Parts List and Diagram for Morse Kit # 5017KIT-P

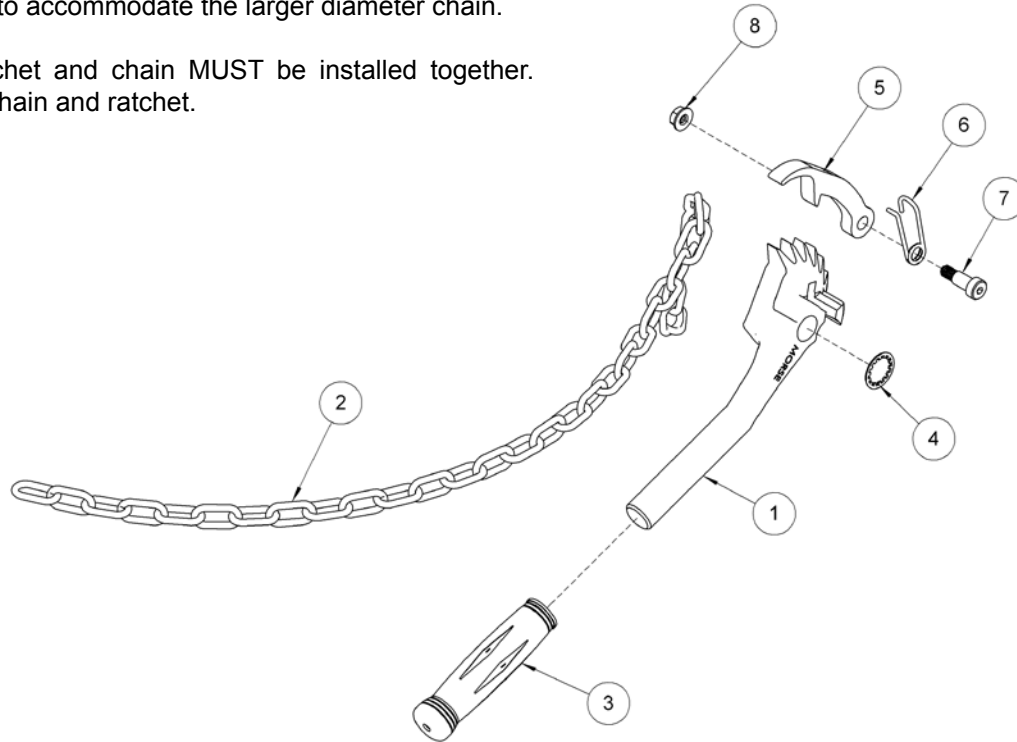
This kit is required to replace the 3/16 alloy cinch chain (part # 180-P) and ratchet (part # 165-P) on Morse drum holders. The 3/16 chain is no longer available and has been replaced by a 9/32 alloy chain. The ratchet (part # 165-P) needs to be replaced in order to accommodate the larger diameter chain.

Replacement ratchet and chain **MUST** be installed together. Discard existing chain and ratchet.
